## APPENDIX E

### Elephant & Castle to Crystal Palace Quietway (QW7) **Falmouth Road to Albany Road** Detailed Consultation Comments and Responses

**Q3. Do you support the removal of footway parking on Brandon Street, near junctions with East Street, to improve access for pedestrians?**

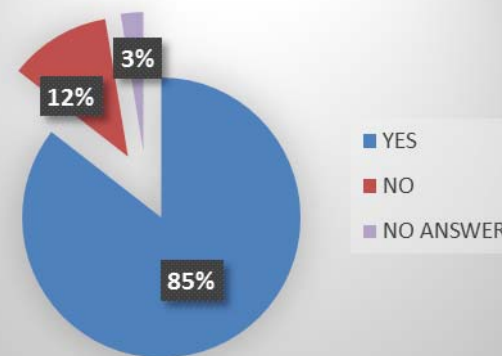
Reference No.	Support	Comment	Key Considerations (and Responses)
10	Yes	As a less confident cyclist who lives in the area I think this is a life-changing proposal - I will be able to cycle freely and without worry. I'm also a pedestrian so I thoroughly support the removal of footway parking on Brandon Street.	<i>Not Required</i>
14	No	Parking in and around East street market is vital for its continuation the market cannot afford to lose the 12 parking spaces in Portland street that has been allocated to be deleted	<b>Loss of parking for East Street market:</b> <i>The removal of footway parking is aimed at improving conditions for pedestrians and cyclists by removing obstructions. Existing 1.2m footway is inadequate for wheel-chair or pushchair users. Loading and unloading is permitted on single / double yellow lines for a short period.</i>
32	Yes	Yes, but are the 77 lost parking spaces going to be replaced. I run my own business which requires vehicular transport and not being able to park nearby will cause me serious transport and finance issues.	<i>Proposals would not restrict loading in this location so would not have an adverse impact on deliveries to market traders.</i>

(60) SOUTHWARK ASSOCIATION OF STREET TRADERS	No	I am the Hon. Secretary of the Southwark Association of Street Traders, having served as such for over 40 years. I write following discussions by the majority of the traders in east street market. Traders are upset that having discussed the matter with councillors and officers of the council at a meeting on the 1st July 2015 we were told that there will be no loss of footway parking at the junction with east street or Portland Street. This junction is very important to the traders in east street market, it is essential to traders in refreshing the stalls with stock etc from the storage sheds around Portland Street and Brandon Street. Traders would at least like to have the opportunity to have notice of talking with officers etc.	<i>Parking stress survey to inform decisions regarding parking around the</i>
65	No	I object to the removal of the parking from the footway Brandon Street (3

<p>parking spaces), Portland Street south of East Street (9 parking spaces). As I live very close to the parking, in fact I overlook one of them in Brandon Street. There is no problem for pedestrian use, in fact I use them myself on a daily basis.</p> <p>With all the removal of these parking spaces either Brandon Street, Portland Street you will be making it more difficult for residents to park in the area where they live. It will also cause a problems for the Market Traders and Shoppers who also use them too.</p> <p>The Council has already made it extremely difficult with the removal of parking on Stead Street for building. Parking is becoming more and more difficult in the area.</p> <p>Accidents will still occur even if these 3 and 9 parking spaces are removed, it has nothing to do with visibility, it's just to give cyclist a clear run. The Market is in place for six days and most accidents occur at night, when there are few or no cyclist.</p> <p>This measure for the removal of the parking will have an adverse effect on the area for shops and people coming to do shopping.</p>	<p><i>junction during detailed design.</i></p>

52	Yes	Please consider the possible effects on residents parking if market visitors want to park.

**Q4. Do you support proposed two-way cycle lane on Rodney Place and Rodney Road into Content Street?**

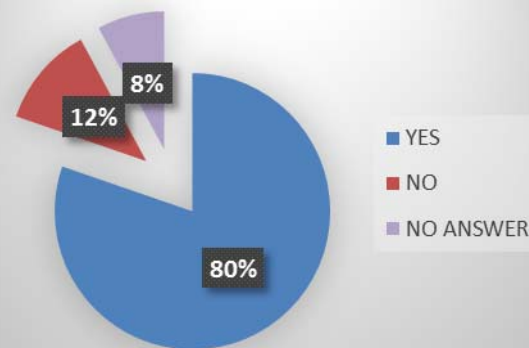
Reference No.	Support	Comment	Key Considerations (and Responses)
(21) HEYGATE ESTATE DEVELOPM ENT	No	<p>We believe that in order to mitigate the risk of injury to cyclists, QW7 should in the short-term not be directed along Rodney Road and Rodney Place until after the redevelopment of Elephant Park has completed. We understand that some cyclists will choose to use this route as it currently forms part of LCN23, but believe that vulnerable cyclists must be assisted in avoiding this heavily trafficked route until construction works have completed.</p> <p>We are generally supportive of the plans that were discussed by Southwark Council and TfL for an alternative Quietway route along Balfour Street and then directly north to the New Kent Road and then Harper Road, keeping it off Rodney Place and the majority of New Kent Road altogether. We think this or an alternative route to be adopted until the construction of Elephant Park is complete.</p>	<p><b>Safety concerns for cyclists:</b>  <i>Alternative route (through Balfour Street, New Kent Road and Harper Road) is indirect and not supported by TfL/Cycling Commissioner. This route is more direct and therefore it is important that the route on cyclist desire line is made as safe as possible as it will continue to be heavily used.</i></p>

6	Yes	How cyclists are supposed to turn from Rodney Place into New Kent Road and vice versa is not clear at all from the plans.	<i>Cyclists to join existing segregated cycle facility on New Kent Road.</i>
7	Yes	These works do not go far enough - they miss obvious synergies with other projects or proposals and do nothing for the conflict between cyclists and pedestrians on New Kent Road and the crossing, or newly-generated rat running traffic. There should be a separate lane and crossing for cyclists, and clearly demarcated space carved from each pavement to prevent conflict between cyclists and pedestrians - the north end of Rodney Place is a particular bad spot - I suggest a designer	<i>Potential to extend / enhance existing segregated cycle facility on New Kent Road to improve connectivity with Rodney Place two-way cycle lane. Further preliminary design required.</i>

observes this for 15 mins in the peak and then you propose something that will guide pedestrians away from bikes, and warn cars heading north that bikes are about to cross their path.	
42	Yes	The proposals for segregated facilities at Rodney Place are very welcome and will be much safer. I support them strongly.	<i>Noted</i>
43	Yes	I am concerned by the use of a zebra crossing at the Rodney Road/Content Street junction. Cyclists do not have priority at a conventional zebra crossing, so one of the new "cycle zebras" should be used here which has a separate cycle crossing in parallel with the pedestrian crossing and cars must stop for both.	<i>A 'tiger' crossing layout will be considered in the preliminary design and detailed design stage of this project.</i>
56	Yes	Installing a segregated track on the eastern side will require cyclists to cross the mouth of Rodney Place, across a lane of northbound motor vehicles who are trying to merge into NKR, as well as stay out of the way of pedestrians legitimately crossing RP. Is there no way to place the segregated track on the western side of RP, manage a (traffic light-controlled?) crossing at the junction of RP and Rodney Road, and continue the segregation along the south side of Rodney Road? (Which also removes the need for a tricky crossing into Content Street?)	<i>The eastern side of Rodney Place is unsuitable for the cycle-way provision due to the Heygate Estate currently being constructed and access to the site required.</i>

65	No	The proposal for a two way segregated cycle lanes Rodney Road into Content Street. The part of the proposed section on Rodney Road for this segregated cycle lane, is already far too small and narrow to suggest placing a cycle lane. Even before the building works that are going on, it's already far too tight for vehicles passing one another. It's far too narrow on this part of the road.	<i>Existing overall road width for Rodney Road is 14m. This allows adequate space for a 4m two-way cycle track (including segregation) and two wide general traffic lanes.</i>
77	Yes	According to the Southwark cycling map, this quietway will be rerouted through the new development once completed and lead into Meadow Row. It is unclear when this would happen but there is a real risk that the cost of the two-way track would be poor Value for Money given its limited use before the route is changed. In addition as the primary flow of cycles would then be on LCN route 2 along Heygate Street rather than via Rodney Place, it might hinder rather than help.	<i>Specific development timescales. The undertaken development works are not part of this scheme.</i>

**Q5. Do you support northbound one-way working on Rodney Place, between New Kent Road and Munton Place, cyclist exempt?**

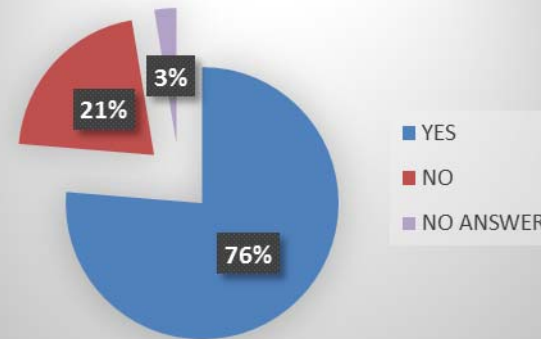
Reference No.	Support	Comment	Key Consideration
56	Yes	I fully support the conversion to one-way. Cycle flow in the AM is very high in a northerly direction, with a desire line to cross the mouth of Rodney Place and continue along NKR in a westerly direction.	None
32	No	The proposal is unclear. How exactly would a one way system work? Would need to see the whole provision, not just section. This would mean we will have to come via E&C roundabout on the way home (via car) causing delays to us and further congestion. This road is the primary access to the Rodney Road area if travelling south bound from Tower Bridge making this a north bound only road is going to push considerably more traffic onto the already congested E&C roundabout and Old Kent Road.	<b>Congestion on E&amp;C Roundabout</b> <i>One-way proposals would increase some journey times and may increase the usage of E&amp;C Roundabout but are intended to remove as far as possible inappropriate motor traffic from the cycle route</i>

57	No	If one way on Rodney Place and no right turn off Rodney Road into Rodney Place then a lot of traffic will be diverted onto E&C Roundabout system, causing more congestion on Walworth Road Roundabout.	
65	No	All traffic will be filtered down the New Kent Road towards the Elephant and Castle with no left turn into Rodney Place or because of the no right turn from Rodney Road into Rodney Place the traffic will be filtered down Heygate Street onto the Walworth Road, this will only allow cyclists to use Rodney Place. All of this will make the area more congested.

**Q6. Do you support right turn ban from Rodney Road into Rodney Place to discourage rat-running to / from New Kent Road?**

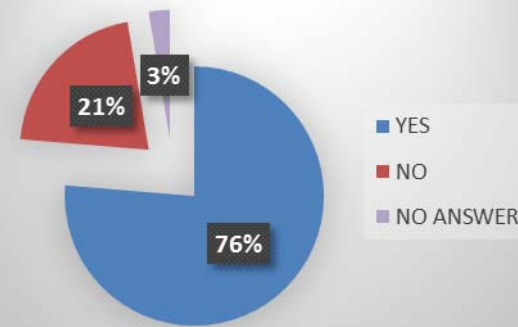
Reference No.	Support	Comment	Key Considerations
5	Yes	I do encourage the closure of 'rat-runs' and strongly encourage you to close all the loop holes. If this plan proceeds I still think that 'rat-running' will be possible along Balfour Street and then right into Rodney Place and motorists will find and use this thus defeating the intention. It is essential that a Quietway is just that, otherwise the whole scheme is compromised.	<p><b><u>Displacement of traffic on surrounding road network</u></b>  <i>Congestion on E&amp;C Roundabout – One-way proposals would increase some journey times and will increase the usage (congestion) of E&amp;C roundabout. Alternatively, vehicles will turn from Rodney Road into Balfour Street into Munton Road and re-join Rodney Place.</i></p> <p><i>Inappropriate manoeuvres may occur on Rodney Road / Heygate Street – issue will be investigated at detailed design stage.</i></p>

22	No	I most certainly disagree with Q6 purely because to get into new Kent road the only way would be to go through east street then onto Old Kent Road and to Walworth Road and around the elephant and castle which is a nightmare already!!! I experience a similar problem from where I live to try and get to Portland Street, I have to either go out onto Walworth road and then down Albany Road into Portland Street or out onto Walworth Road along to Brandon Street then into Portland Street all because someone thought it was a good idea to close Lytham Street into Liverpool Grove by St Peter's church, this now makes what would have been a 5 minute trip into up to an hour and you can almost forget it on a Saturday!! The same will happen with Rodney Place/Road - you need to walk these routes and see what we have to do!!! Just to make a short trip.	
32	No	Maybe, this will push more traffic onto the roundabout in front of the Strata building. If this is your intention as part of a bigger plan then i think it is a good idea.

37	No	Banning people turning right into Rodney Place from Rodney Road will only encourage people to make u turns on Heygate Road or worse turn

right into Balfour Street then left into Muntun road, we already have problems with people driving down Muntun Road as if it were a race track. If you made Muntun Road a dead end or placing traffic management to make it safer for children i would be happy with that.	<i>Traffic calming or closure on Muntun Road would require additional analysis of the traffic impacts which was not investigated as part of this project.</i>
44	No	It is useful to be able to turn right from Rodney Road into Rodney Place and for friends to come visit by coming down New Kent Road via Rodney Place.	
57	No	If one way on Rodney Place and no right turn off Rodney Road into Rodney Place then a lot of traffic will be diverted onto E&C Roundabout system, causing more congestion on Walworth Road Roundabout.	
59	No	Whilst i support cycle changes in Rodney Place, I disagree with a one way system which will mean more traffic on an overcrowded Walworth Road/ Elephant and Castle junction.

**Q7. Do you support proposal at Albany Road / Portland Street junction?**

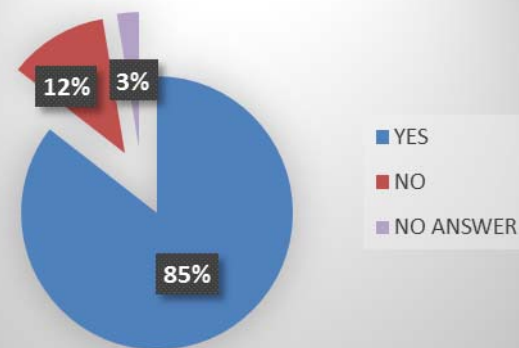
Reference No.	Support	Comment	Key Considerations (and Responses)
3	Yes	Consideration needs to be given to the entrance way and turning space at the Burgess Park entrance.	<p><b><u>Access to Burgess Park</u></b>  <i>Access to Burgess Park via Albany Road maintained in the current proposals.                      Access to Burgess Park via Wells Way to be considered as part of a separate project.</i></p>
34	Yes	There should also be improved provision for cyclists entering Burgess Park by turning right into Wells Way from Albany Road, and then immediately left into the park. Under the proposals I believe these cyclists either will not use the mandatory cycle lane on Albany Road, or will have to leave it to cross a lane of fast moving traffic to get into the right filter lane.	
41	Yes	Many (hundreds?) of cyclists travel north/south using Portland St, burgess park and the surrey canal route. The junction Portland St/Albany Road also is informally used as a key entry/exit to the burgess park by these cyclists. Could your design be modified to enable this?

4	Yes	The parking bay on Albany Road puts cyclists in the door zone of parked vehicles and should be removed. Opposite this there is a gap in the segregated cycle lane but no vehicle access. This gap will probably be used as an informal parking/loading bay so the segregation should be continuous here. Portland Street is easily wide enough to accommodate a segregated cycle track in both directions.	<p><b><u>Cyclist Safety in Albany Road &amp; Wells Way</u></b>  <i>Road safety audit will be carried out and parking bay location will be assessed.                      The segregation (semi-segregation) of the northern cycle lane will be investigated in preliminary design (SSDM process)                      Possible improvements to Wells Way junction to be considered and promoted</i></p>
55	Yes	Semi-segregation of Albany Road mandatory cycle lane should be considered.	
42	Yes	The proposals for the Portland Place / Albany Road junction are generally good and I support them. However they are weak in two

<p>respects:</p> <p>Firstly, the mandatory cycle lanes eastbound on Albany Road are likely to be ignored by motor traffic as commonly occurs in the Borough. If there isn't enough space for full segregation these lanes must at least be semi-segregated with wands / armadillos and planters - and the lane routed inside the parking bay, not outside it;</p> <p>Secondly, the scheme assumes cyclists heading south will continue straight on into the park, instead of heading east then south on Wells Way, as at present. Accordingly, there is no provision at all for cyclists to safely turn right (south) on Albany Rd into Wells Way. I do not think this is a good idea as (a) it will funnel a lot of cyclists through the park if it works, which the park users are against. And if the scheme doesn't work, and cyclists continue to choose the Albany Road/Wells Way route south, they will not be able to turn right safely (cars will not expect right turning cyclists any more). These defects must be rectified.</p>	<p><i>outside of the QW7 programme.</i></p>

56	Yes	<p>Junction of Portland Street and Albany Road: I partly think it's not worth designing this section until the Albany Road / Wells Way junction is clearer. Huge AM cycle flow from Burgess Park onto this junction (which is currently quite messy), then huge flow from AR turning right into PS. Does the junction bypass help cyclists travelling this direction, from SE to N? If the cyclist light holds cyclists for longer than the current all-traffic light, then why would I use it?</p>	<p><i>Confident cyclists wishing to join main traffic can still use the general traffic phase at the signals.</i></p>
65	No	<p>Portland Street/Albany Road Junction.</p> <p>9.1 Again parking lost to the area, which I object to just to make a segregated cycle lane.</p> <p>9.2 You intend to make pedestrian crossing shorter, narrowing the Albany Road/Portland Street. Again I object, it will help bring congestion to both roads.</p> <p>9.3 To widen footway. There is very little footfall at the moment, so why widen.</p> <p>9.4 To moderate increase in the signal cycle time phasing. This will only again increase more delays for other traffic use and slow it down, again just for cyclists that pass through the area.</p>	<p><i>Loss of Parking – This is a recognised disadvantage of the proposals, but major improvements for the safety of cyclists is made possible as a result.</i></p> <p><i>Congestion – Minimal impact on capacity and delays are expected at this junction.</i></p> <p><i>Proposals include footway widening to promote sustainable modes of travel such as walking.</i></p>

(67) SOUTHWARK CYCLISTS	Yes	We note that the plan for the right turn from Albany to Portland will be unlikely to cope with the expected numbers of cyclists unless more space is assigned and the phasing of the lights gives enough time.	
73	Yes	Albany road and Portland street, it would be better for pedestrians if the zebra crossing points over the cycle lane lined up with the crossing points across Albany Road. Not good to have too many people waiting in between the cycle lane and the road.	<i>Uncontrolled crossings located as per relevant guidance to indicate the segregation of the crossings.</i>

(76) WHEELS FOR WELLBEING	Yes	<ul style="list-style-type: none"> <li>Do the pedestrian crossings on Albany Road really need to be staggered? Better for disabled pedestrians if the crossings are straight and direct.</li> <li>Unclear if cyclists heading west in Albany Road bypass are held by signals or just giveaway markings when cyclists are joining from Portland Street.</li> <li>Can more space be given for the right turn manoeuvre from Albany Road bypass into Portland Street? Perhaps by opening gaps more?</li> <li>The ASL appears to be redundant for cyclists heading West on Albany Road. Compare with no ASL provided southbound on Portland Street.</li> </ul>	<p><i>Cyclists on Albany Road give way to cyclists on Portland Street when required.</i></p> <p><i>Additional stacking space to be considered in detailed design.</i></p> <p><i>Cyclists wishing to do so, can still use the general traffic phase of the traffic signals.</i></p>

74	Yes	The Albany Road junction needs more work as southbound cyclists need some type of protected right turn, motor traffic speeds on Albany Road are high and some measures to reduce speeds need to be developed rather than just taking cyclists off the main carriageway at this location. Road space needs to be reduced to single lanes rather than multiple lanes. The left hook danger still exists for eastbound cyclists on Albany. Are cyclists expected to cross 2 lanes of motor traffic to enter Wells Way?	
77	Yes	<p>Burgess Park /Albany Street</p> <p>The cycle track leading into Burgess Park is the best part of the scheme and the extra greenery is particularly welcome. The junction arrangements may be insufficient for peak hour cycle flows in summer however.</p> <ul style="list-style-type: none"> <li>The track on the southern end of Portland Street should be stepped (as Camden have provided on Pancras Road) rather than kerbed. This would allow greater effective width and so higher flows of pedal cycles per signal cycle. In addition, people would be able to switch to the road if they miss the cycle signal and so avoid such a long wait.</li> <li>TfL is developing new sensors to adapt signal timings to cycling levels -</li> </ul>	<p><i>Additional stacking space to be considered in detailed design.</i></p> <p><i>Signal operation comments to be passed on to TfL.</i></p> <p><i>Request to be considered during Detailed Design stage.</i></p>

<p>LB Southwark should request trialling here.</p> <ul style="list-style-type: none"><li>• The Dutch sometimes provide two pedal cycle phases per signal cycle at peak times, sometimes two short bursts: this could be considered here too.</li></ul> <p>A dropped kerb should be provided to enable people to cycle into the BMX track entrance</p>	
--	---	--
